D12 14.12 Transportation

This report section is D12 of Part D Submissions Analysis of the section 42A report on the Infrastructure and Energy topic, Proposed Waikato District Plan.

14.12.5.22 Figure 1: Approach Sight triangles for level crossings with “Give Way” Signs

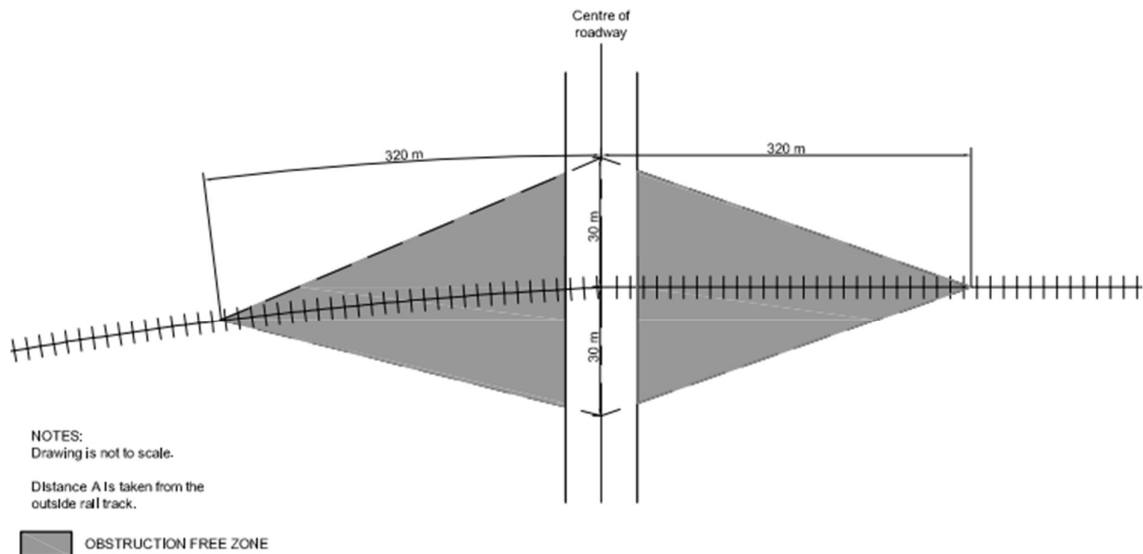
27. KiwiRail has developed a sight triangles standard which requires areas are kept free of physical obstructions (erected or placed) from the standards developed by NZTA, contained in the Traffic Control Devices Manual 2008, Part 9 Level Crossings, which prescribes the formula for sight lines. The submitter considers that including these diagrams in the District Plan addresses the need to avoid the poor location of land uses, which can obstruct the required safety sight lines for uncontrolled (i.e. no barriers) railway level crossings. The submitter notes that one of the key factors in maintaining safety is to ensure road vehicle drivers are presented with sufficient visibility along the rail tracks and obstructions do not block the visibility of level crossing signs or alarms to approaching driver. The submitter also states that Policy 6.5.2 – Construction and operation of the land transport network supports the inclusion of level crossing sightline diagrams in the Plan.

On sites adjacent to rail level crossings controlled by Give Way signs, no building, structure or planting shall be located within the shaded areas shown in 14.12.5.22 Figure 1. These are defined by a sight triangle taken 30 metres from the outside rail and 320 metres along the railway track.

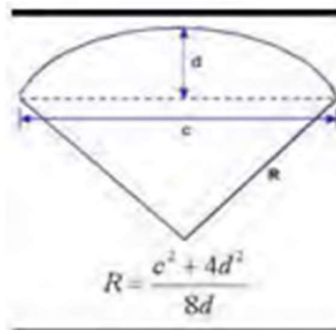
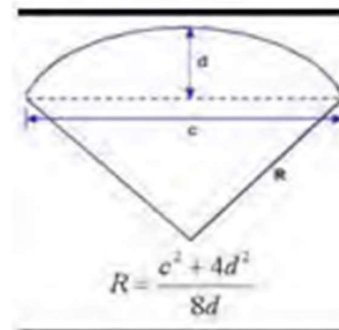
382. **Waikato District Council** [697.82] seeks to amend Table 14.12.5.3 by replacing the term “Speed Environment” to “Design Speed” as this is more accurate terminology. As discussed above, the term “Design Speed” more accurately reflects the speed environment and the amendment is consistent with recommended amendments to Table 14.12.5.1. **Waikato District Council** [697.83] also seeks to include the following additional table and diagram underneath Table 14.12.5.3 to include design speeds for road curves:

386. Add the following table and figure under Table 14.12.5.3 as follows:

27 Figure 14.12.5.4 - Minimum sight distances

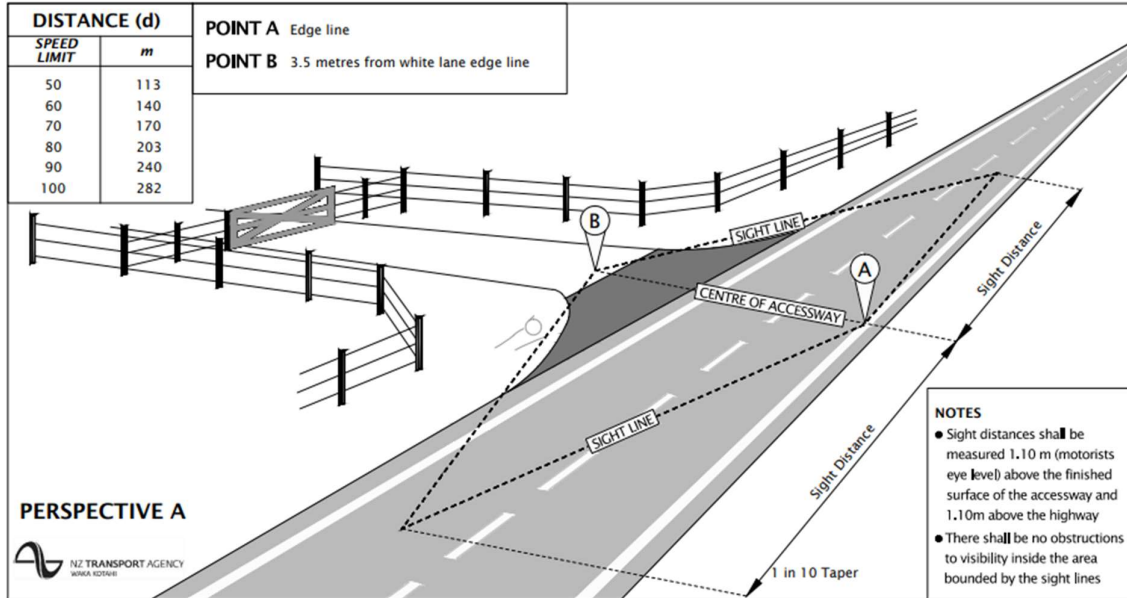
393. **NZTA** [742.113] considers Figure 14.12.5.4 is critical to interpretation of Table 14.12.5.3, but requires amendment to ensure it is consistent with the Transit NZ Planning Policy Manual and Austroads Guide to Road Design Part 4A: Unsignalised and Signalised Intersections (2017 Edition) (from where the PWDP Figure 14.12.5.4 was adapted).

394. I note that Figure 14.12.5.1 has been rolled over from the Operative District Plan Waikato Section (Part 3 – Appendix A3 – Figure 9. I consider it appropriate for Figure 14.12.5.1 to be consistent with national guidance on minimum sight distances. I recommend accepting NZTA [742.113], amending the sight distance diagram to align with Perspective A diagram from Appendix 5b of Transit NZ Planning Policy Manual (2007).

396. Replace Figure 14.12.5.4 with the following figure:

397. In my opinion, amending Figure 14.12.5.4 is effective and efficient because it provides both consistency with national guidelines on minimum sight distances and certainty regarding implementation. The risk of not acting is uncertainty for implementation, resulting in additional regulatory costs.

31 Table 14.12.5.8 - 90th Percentile car tracking curve minimum radius

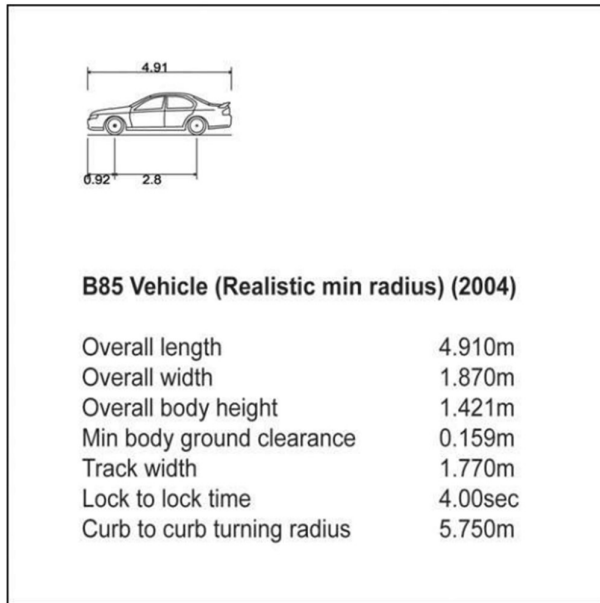
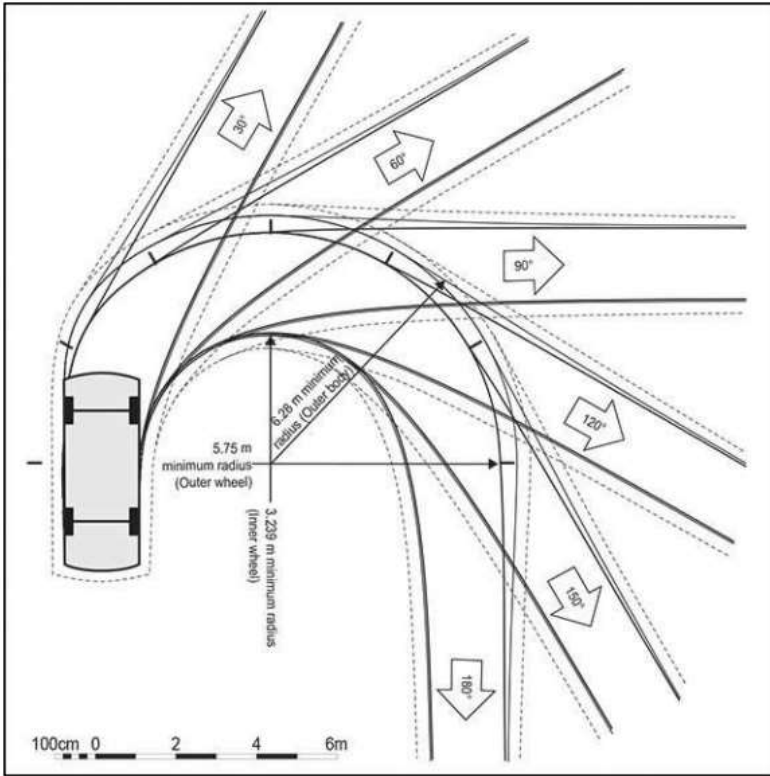
Submission point	Submitter	Decision requested
742.116	NZTA	Replace Figure 14.12.5.8 - 90th percentile car tracking curve minimum radius with vehicle dimensions from Figure B2 and the tracking curve from Figure B5 of AS/NZS2890.1:2004

475. NZTA supports the inclusion of Figure 14.12.5.8 in the Plan. However, AS/NZS2890.1:2004 describes the 85th percentile car as longer than the 90th percentile car used in Figure 14.12.5.8.

- a. As the industry standard car tracking curve, I recommend accepting NZTA [742.116].

476. Replace Figure 14.12.5.8 with the following two figures:
